SMYRNA SCHOOL DISTRICT
Smyrna Elementary School Renovations and Addition
Bid Number SSD-15-001

ADDENDUM NO. 3

27 March 2015

ARCHITECT'S PROJECT NO: 14107a

4.5 **DRAWING E11-01**

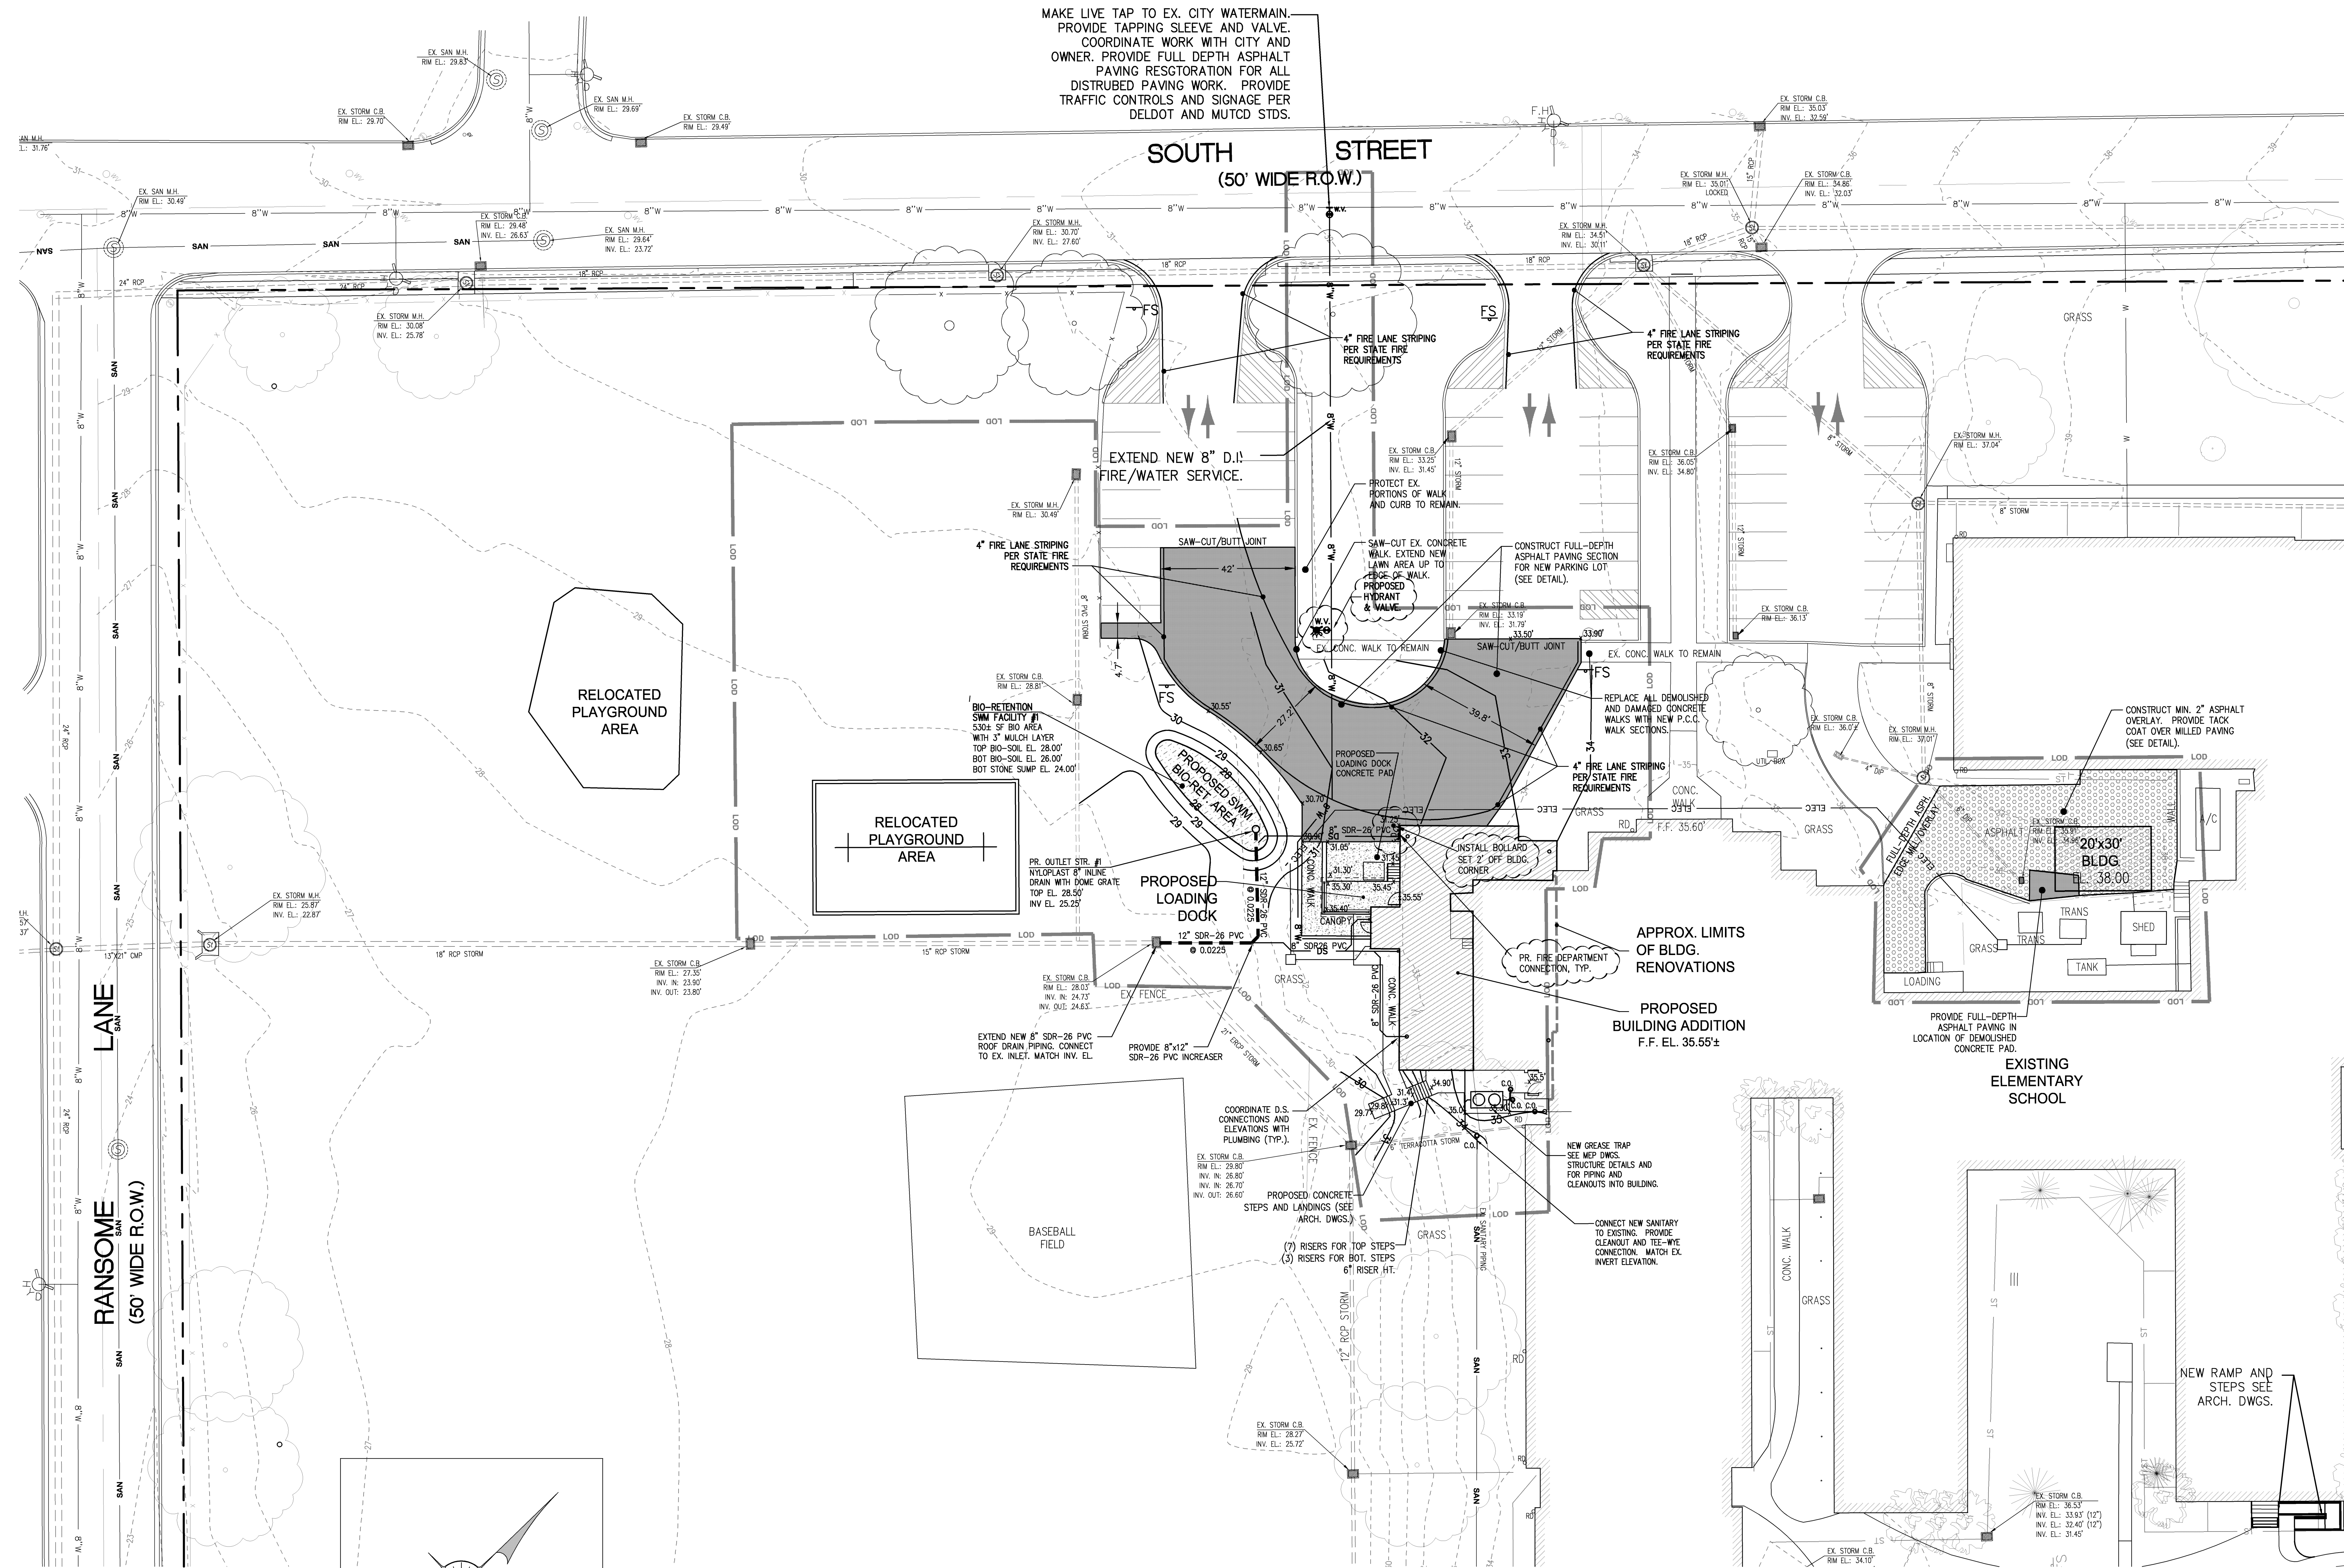
In Multipurpose Room/Stage-Room 141, there are currently, ten (10) Type D fixtures shown to be provided. This ceiling will be removed and a new 2x2 suspended ceiling will be installed. Omit the installation of the Type D fixtures and substitute with four (4) Type A and four(4) Type A1 fixtures. Provide wiring and switching as shown.

SCALE: **C-04**

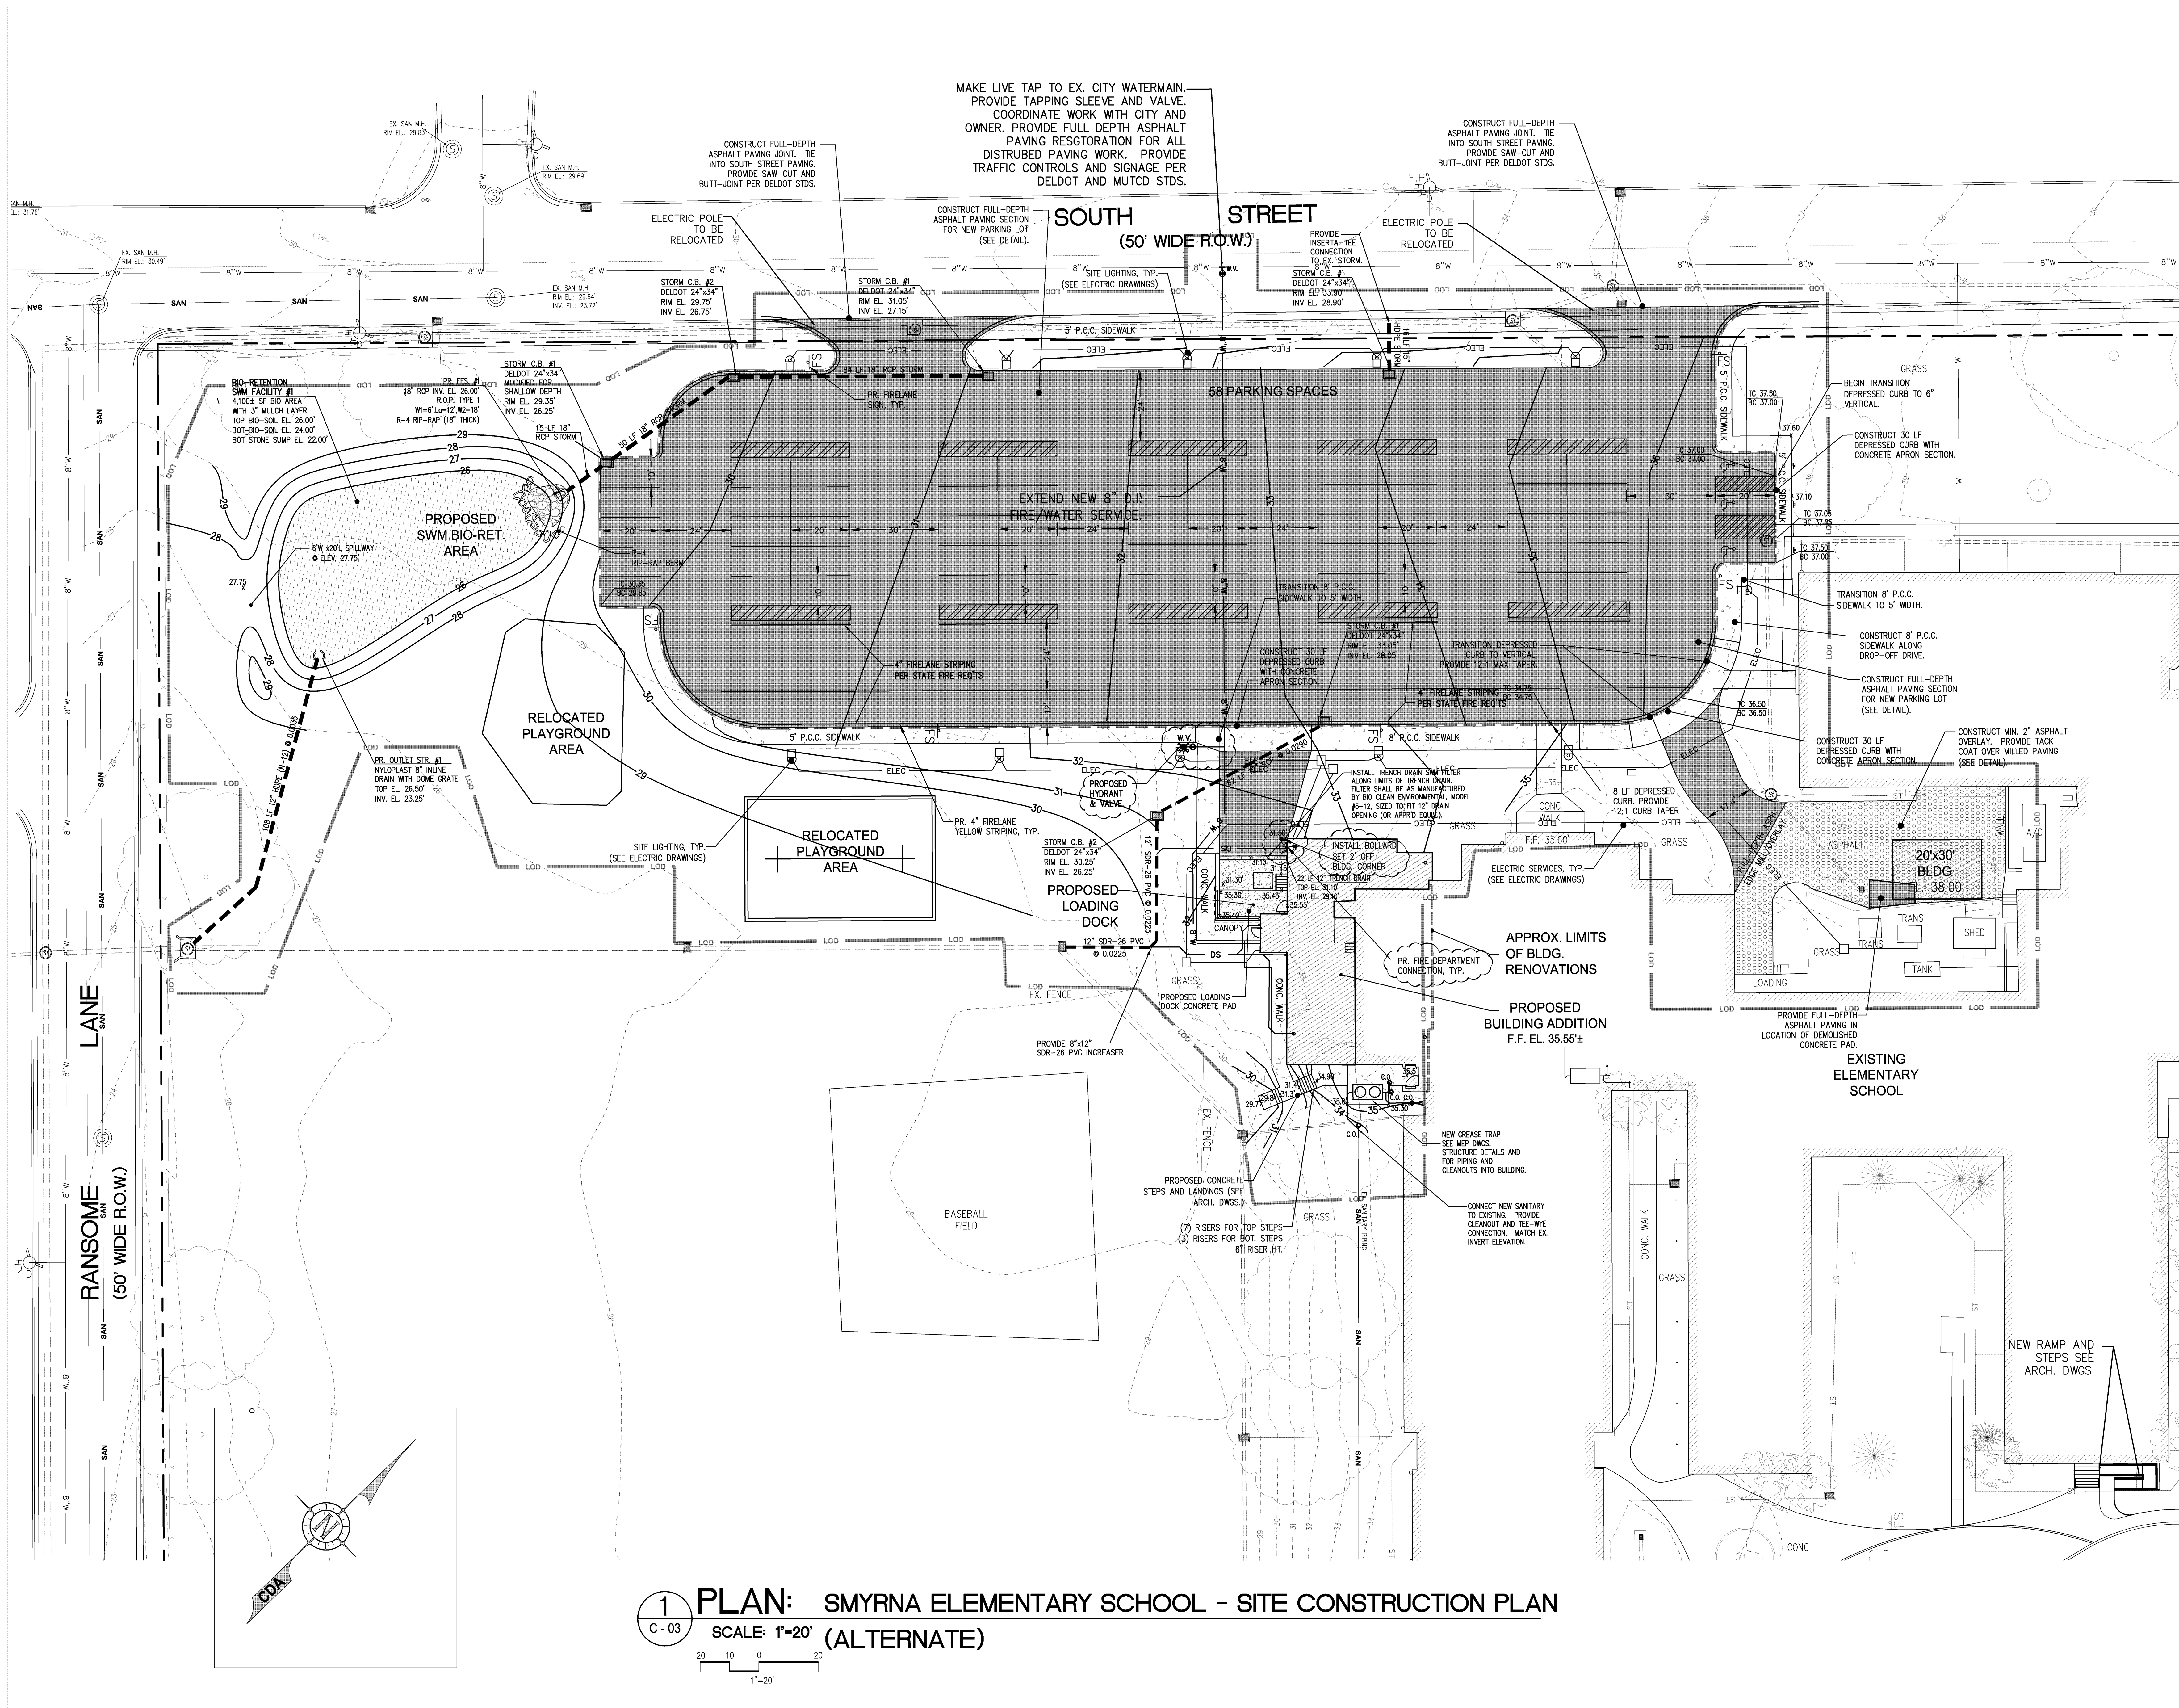
2.4 **Q:** Per detail on C-09, are any of these Bollards needed? I can't locate any on the Civil or Architectural Plans, please advise

2.43 **Q:** Electrical site plans show a new fire hydrant in both base bid and alternate plans. Civil drawings only show for Alternate Plan. Which is correct?

A: Per detail, add one bollard at the corner of the new kitchen addition, closest to Col lines F and 1.2, 2'-0" off of the exterior face of wall to protect the fire department connection valve. See attached C-04 and C-04 (Alt) Drawings.

A: Both base bid and alternate include proposed hydrant. See revised PDF C-04 for updated drawing.
